Flexible Resource Adequacy Criteria and Must-Offer Obligation Draft Final Proposal, Posted February 7, 2013

Submitted by	Company	Date Submitted
Edward G. Cazalet MegaWatt Storage Farms, Inc. ed@MegaWattSF.com 650-949-0560	NGK Insulators, Ltd.	February 21, 2014

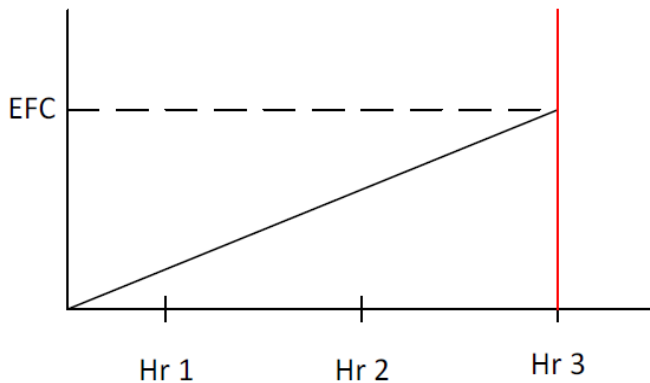
The figure below from the ISO Proposal illustrates this determination of EFC for storage to qualify as fully-flexible capacity. It means that only 1.5 MWh of energy storage per MW (1.5 hours) of storage is required and longer duration storage receives no additional EFC credit.

Most storage and especially fast storage that can provide the most flexibility to the ISO market can respond almost immediately. Applying a reduced, low ramp rate to storage below its capability makes no sense.
